# Work Order ID 97412

Item Name: Crosstube Assembly, Mid Fwd

DRAWING NO. D206-667-147	TITLE CROSSTUBE ASS'Y (206L MID FWD)	REV. A	<b>DART AEROSPACE LTD ENGINEERING ORDER</b>		D.E.O. NO. D206-667-147-A-1	SHEET NO. SHEET 1 OF 1	SCALE NTS
DRAWN <i>q</i>	CHECKED <i>ASS</i>	MFG. APPR. <i>JB</i>	APPROVED <i>MD</i>		DE APPR. <i>MD</i>		
DATE 11.07.15	DATE 11.07.20	DATE 11.07.21	DATE 11/07/21		DATE 11.07.21

DRAWING NO. D206-667-147		TITLE CROSSTUBE ASS'Y (206L MID FWD)		REV. A		DART AEROSPACE LTD ENGINEERING ORDER		D.E.O. NO. D206-667-147-A-2		SHEET NO. SHEET 1 OF 1		SCALE NTS	
DRAWN AJ5		CHECKED		MFG. APPR.		APPROVED		DE APPR.					
DATE 12.08.02		DATE 12.08.02		DATE 12.08.02		DATE 12.08.02		DATE 12.08.02		DATE 12.08.02

**DETAIL P**  
BONDING STRAP INSTALLATION 2 PL

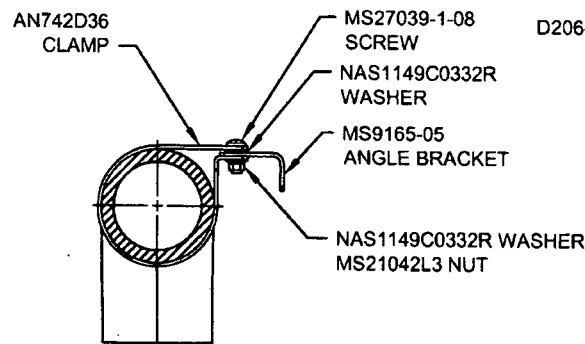
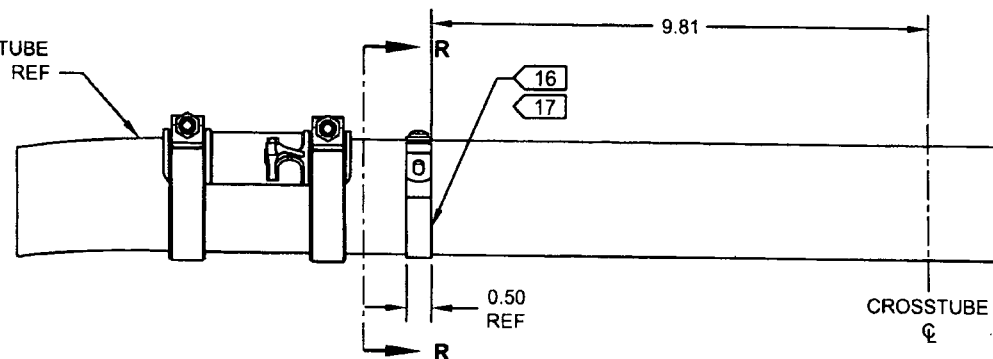
ADD ELECTRICAL GROUNDING STRAP

ITEM	QTY	PART NUMBER	DESCRIPTION
1	X	D206-667-147	CROSSTUBE ASSEMBLY (206L MID FWD)
10	2	AN742D36	CLAMP
11	2	MS9165-05	ANGLE BRACKET
12	2	MS21042L3	NUT (OR MS21042-3)
13	2	MS27039-1-08	SCREW
14	4	NAS1149C0332R	WASHER (OR AN960C10L)

- 16) MASK AREA UNDER CLAMP PRIOR TO PAINTING
- 17) SEAL EDGES WHERE AN742D36 CLAMP MEETS WITH THE CROSSTUBE USING SIKAFLEX-241/-291 OR MIL-S-8802 CLASS B2 OR PROSEAL 890 SEALANT
- 18) PERFORM RESISTANCE CHECK TO ENSURE MAX RESISTANCE IS 10 MILLIOHMS
